TSB: 01-018/15

MULTI-MODEL - CHECK ENGINE LIGHT ON WITH DTC P2610 AND P2507

- This bulletin supersedes the previous bulletin 01-001/13 issued on 01/07/13, 01/16/13 and 09/25/13 and 01-017/14 issued on 10/17/14. The APPLICABLE MODEL(S)/VINS, DESCRIPTION, REPAIR PROCEDURE and WARRANTY INFORMATION have been revised.
- Changes are noted below in Red.

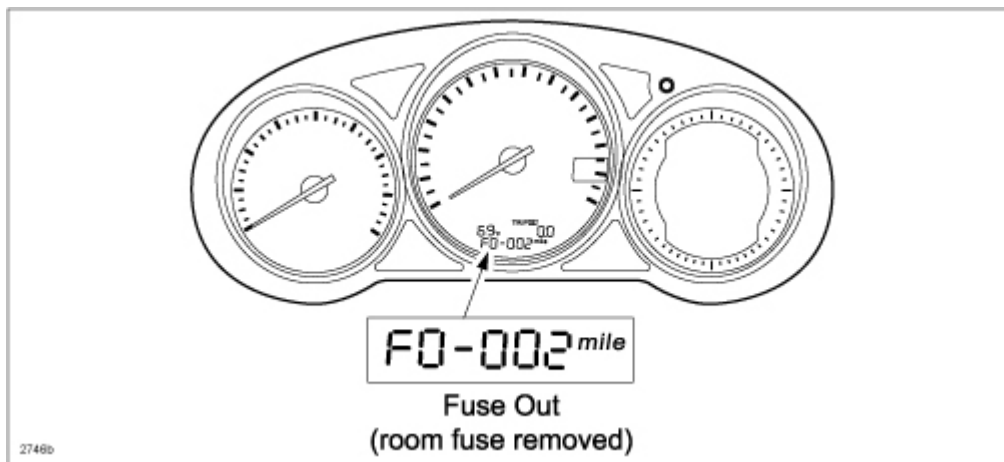
Some vehicles may experience the CHECK ENGINE LIGHT ON with DTC P2610 and P2507 stored in memory after engine start and room fuse 15A (A) removed.

This is caused by the engine being started 3 or more times after a short duration of engine off (less than 15 seconds) with the room fuse removed.

NOTE: The odometer will display "F0-002" during transport mode (room fuse 15A removed). Transport mode is canceled when room fuse 15A is installed or the vehicle odometer is more than 12.4mi (20km).

1. Verify DTC P2610 and P2507 are stored in PCM memory.
2. Install ROOM fuse 15A with ignition OFF.
3. Start the engine and let it run for at least 10 seconds, then stop the engine.

4. Start the engine again and verify that the CHECK ENGINE LIGHT is not illuminated, then stop the engine.

5. Clear DTC P2610 and P2507 from PCM memory using IDS.
